Request	-	Special Use Permit for a Day Care Center
Location	-	3302 Buckeye Street
Applicant + Owner	-	Charles Freeman 3302 Buckeye St. Toledo, OH 43608

STAFF ANALYSIS

SPECIAL USE PERMIT
TOLEDO CITY PLAN COMMISSION
REF: SUP25-0038
DATE: November 6, 2025
TIME: 2:00 P.M.

SITE PLAN

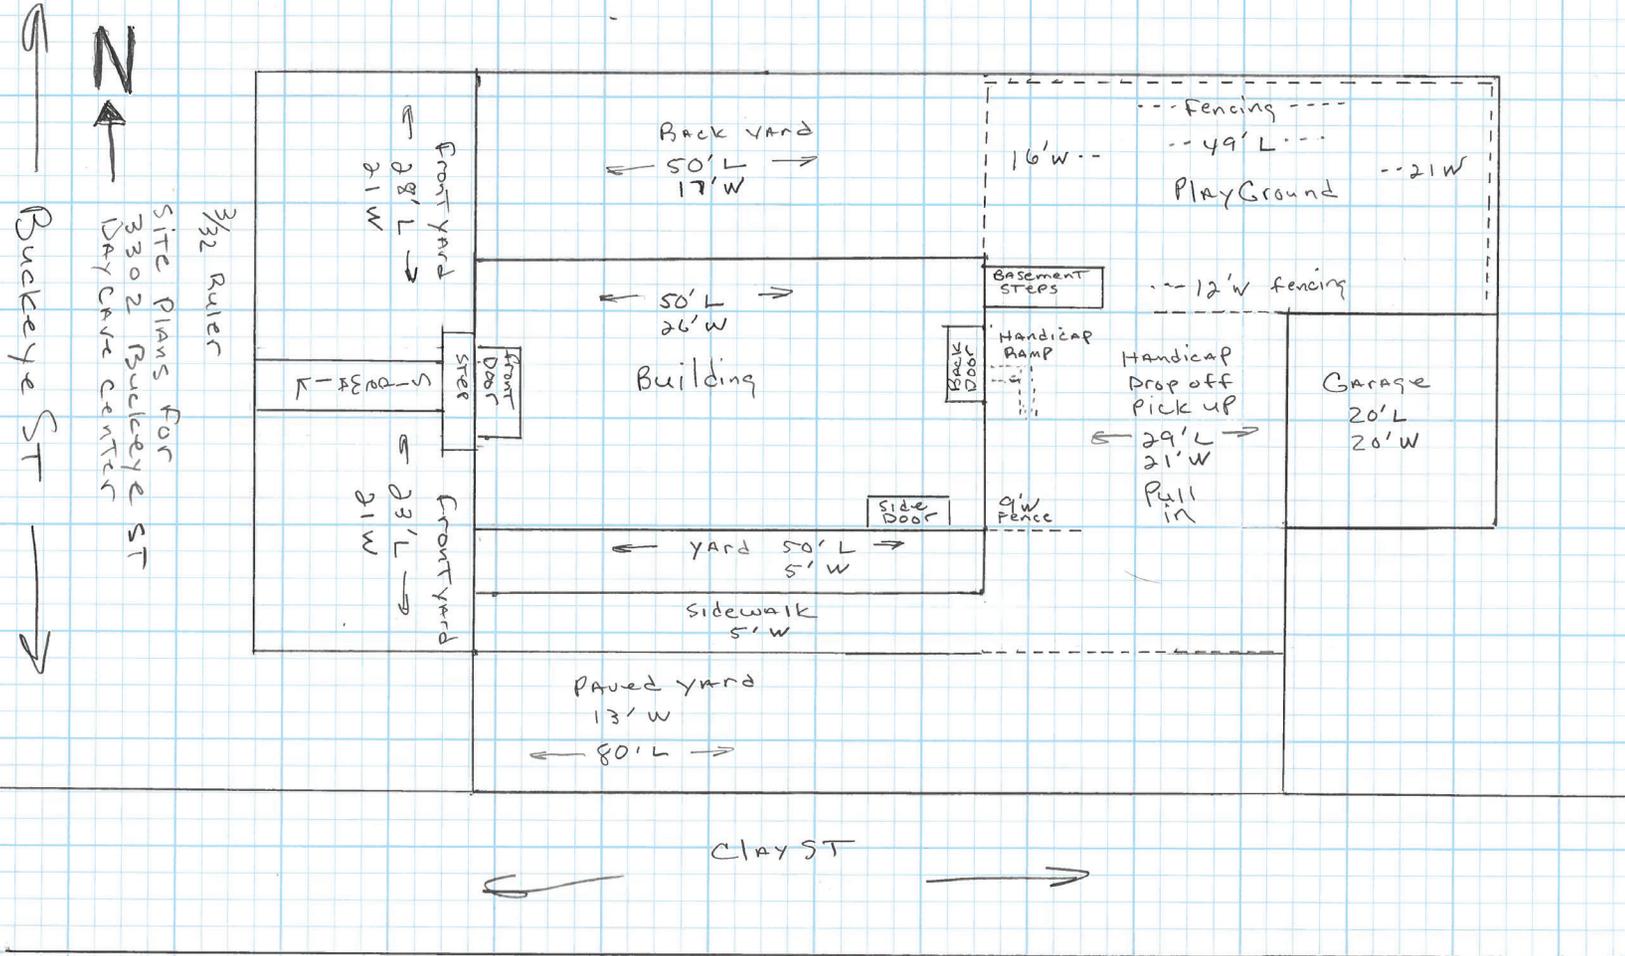
The site plan submitted depicts the outdoor play area on the north east area of the property and is a total of ninety-eight (98') linear feet. Per **TMC§1108.0407(B)**, credit may be given for existing canopy trees. This area of the site has existing trees that may account towards the required plantings for a Type B landscape buffer. The proposed outdoor play area is fenced-in however, the height of the fence is not depicted on the site plan. **As a condition of approval, the applicant shall submit a revised landscape plan which depicts the details of fencing, existing, and new plantings that are compliant with the requirements of a Type B landscape buffer.**

9. Bicycle parking is required per TMC1107.0900.
10. A paved off-street area for dropping off and picking up persons in care at the facility must be provided and approved by the Division of Traffic Management per TMC1104.0700(F). (A revised site plan depicting a pick up and drop off location is required and must be approved by the Division of Traffic Management).

11. Thirty-five (35) square feet of useable indoor space per person in care must be regularly available to the Type A Day Care. **Acceptable as depicted on site plan.**

12. Sixty (60) square feet of useable outdoor space must be provided for each person in care using the outdoor area at any one time. **Acceptable as depicted on site plan.**

- b. A frontage greenbelt shall be provided along all public rights-of-way pursuant to **TMC§1108.0202**. Frontage greenbelts shall be a minimum width of fifteen (15') feet and have at least one (1) tree for every thirty (30') feet of lot frontage. **A minimum of two (2) canopy trees shall be provided along Buckeye Street. Not depicted on site plan, shall be submitted on revised landscape plan;**

- d. One (1) two-inch caliper tree for every 1,000 square feet of building coverage, foundation plantings along all portions of the building that are visible from the right-of-way, and landscaping at all major entrances shall be provided. **Not depicted on site plan. A revised landscape plan shall be submitted to reflect interior site landscaping;**
